SUBJECT: Service Bulletin SEB89-1 Revision 3. Stabilator Balance Weight Arm Bracket Inspection Replacement.

SEB89-1
Revision 3

STABILATOR BALANCE WEIGHT ARM BRACKET INSPECTION/REPLACEMENT

1968 thru 1978 Cardinal and Cardinal RG Series Airplanes

Figure 1. Stabilator Balance Weight Arm Brackets Inspection & Replacement (Sheet 1 of 4)

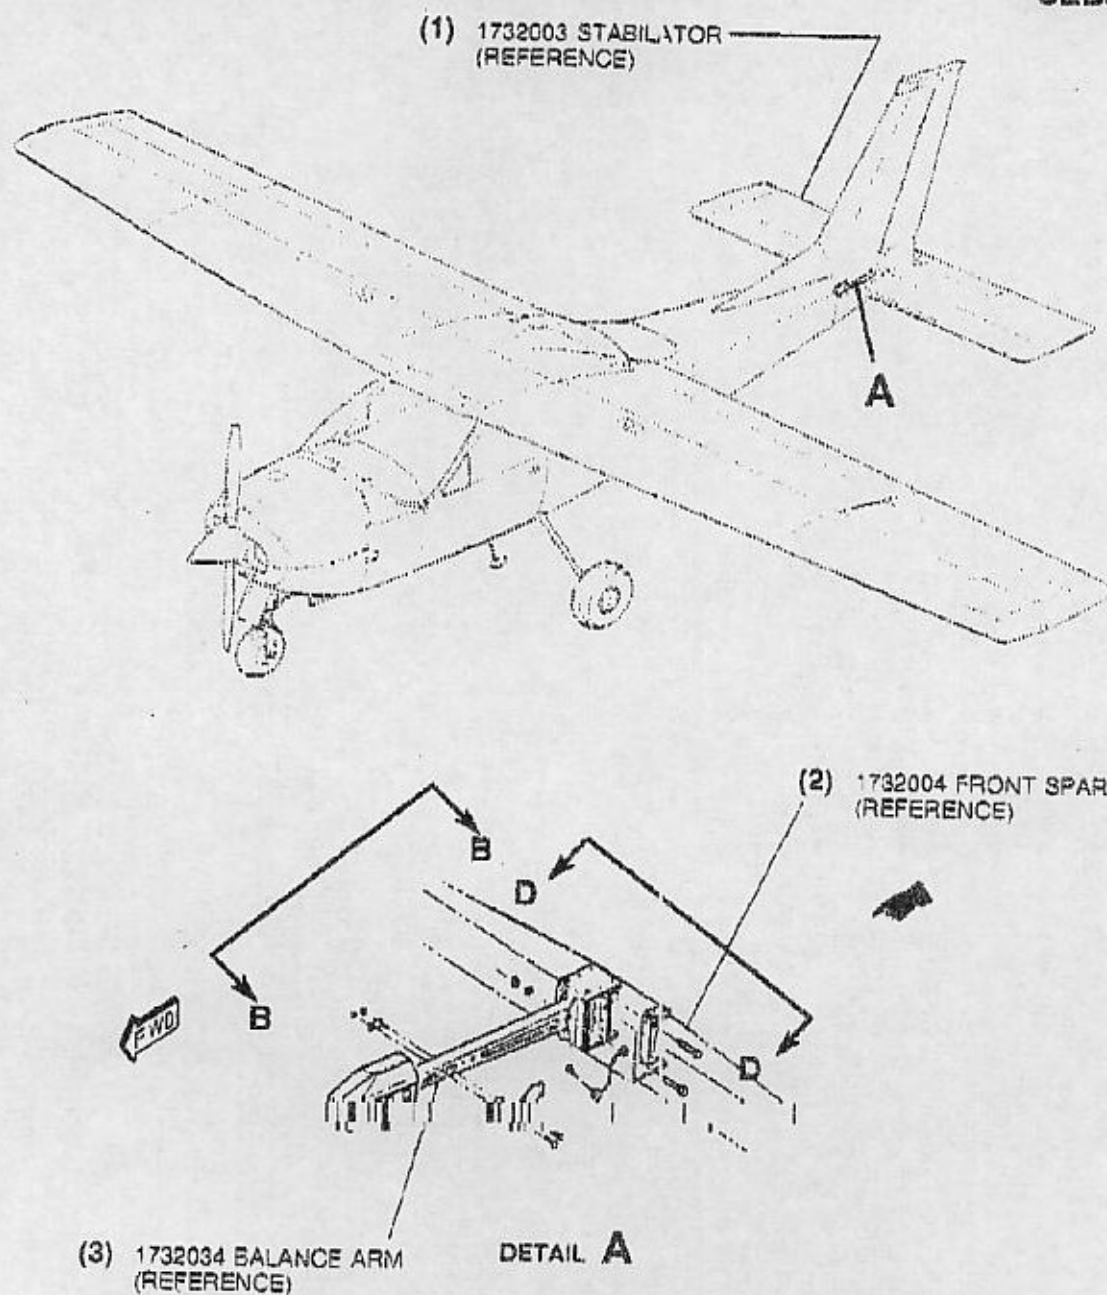
1. Remove stabilator (1) from airplane per appropriate Service Manual (refer to Figure 1, Sheet 1).
2. Remove balance arm (3) from stabilator by removing bolts, washers and nuts (4 & 10). retain balance arm, bolts and washers. discard nuts (refer to Figure 1, Sheets 2 & 3).

5. If a crack or cracks are detected, proceed as follows.
6. (Refer to Figure 1, Detail A, View B-B, C-C & D-D, Sheets 1 thru 4) With the balance arm removed, drill out existing rivets in location (7 & 12) on both RH & LH brackets (5). Remove and discard brackets.

Figure 1. Stabilator Balance Weight Arm Brackets Inspection & Replacement (Sheet 2)

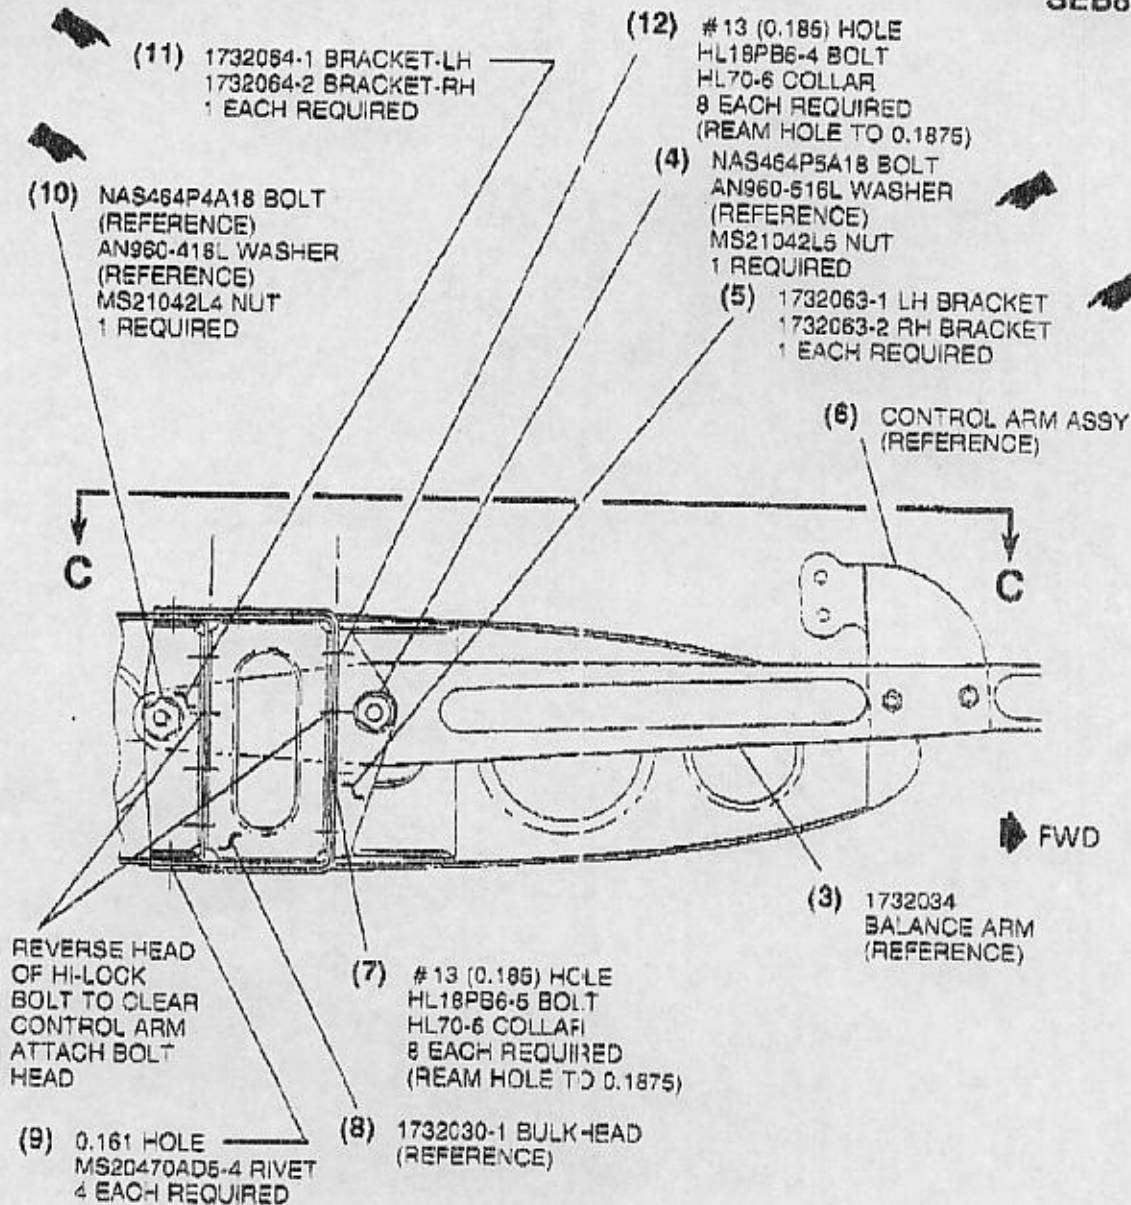
3. Visually inspect RH & LH brackets (5 & 11) for cracks, especially near the radius under the bolt hole. If no cracks are visible, use Eddy Current inspection to verify no small cracks have started.

7. Drill out existing rivets in location (9) on both RH & LH brackets (11). Remove and discard brackets.

Figure 1. Installation of the stabilator (Sheet 4)

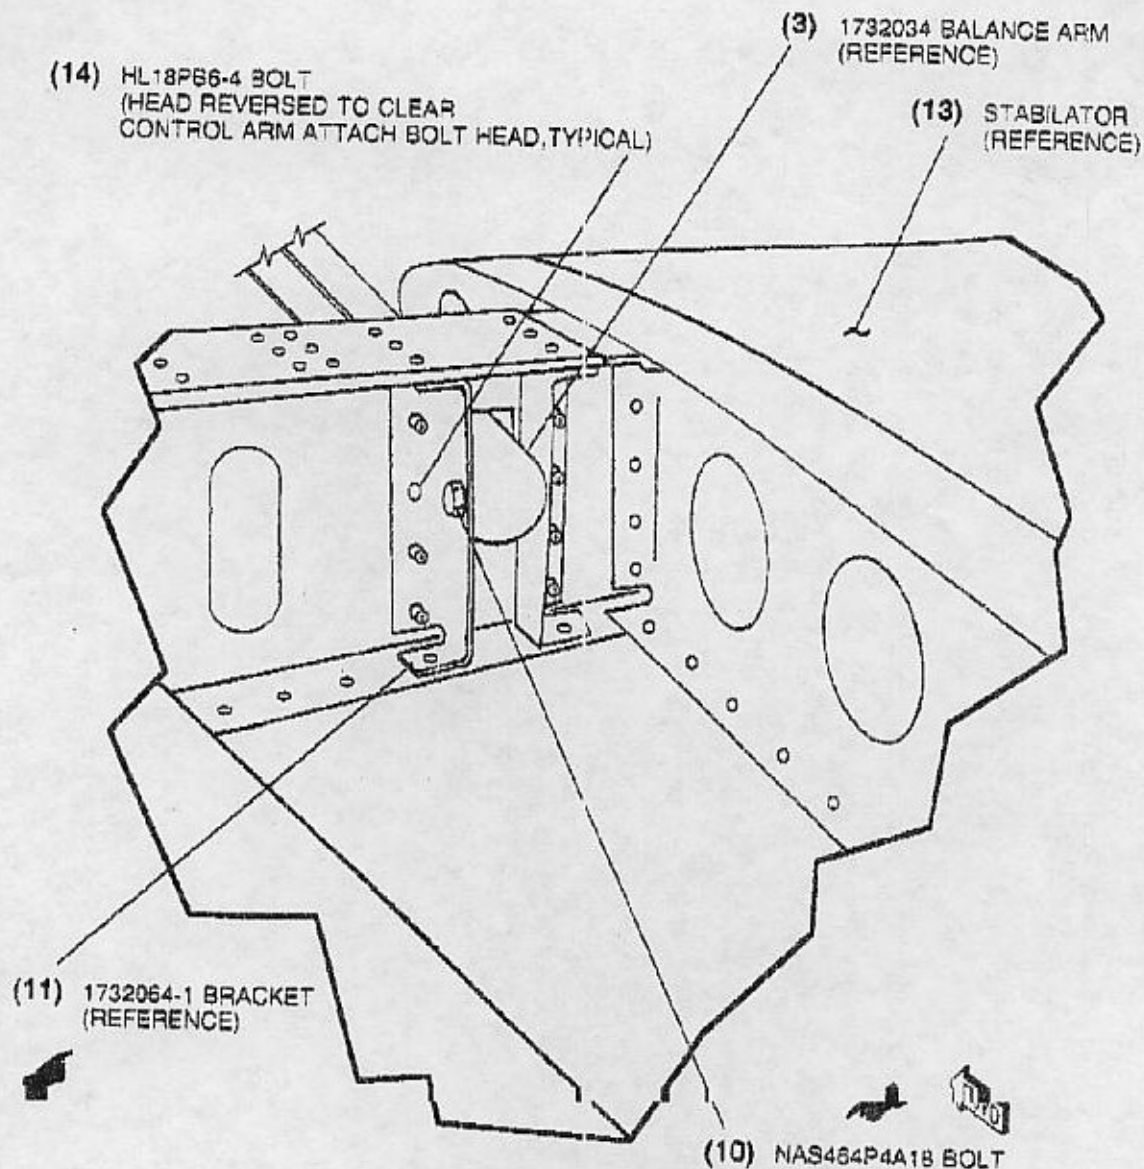
11. Deburr and clean holes reamed in Step 10.
 12. Secure brackets (11) using rivets (9) and Hi-Lock bolts and collars (12). Reverse Hi-Lock bolt head (14) as shown in View D-D, Sheet 4, to clear control arm attach bolt head (10).

13. Repeat steps 9., 10., 11., & 12. For brackets (5) using Hi-Lock bolts (7) and reversing Hi-Lock fastener in the same location as the aft bracket (11) to clear forward control arm attach bolt head.
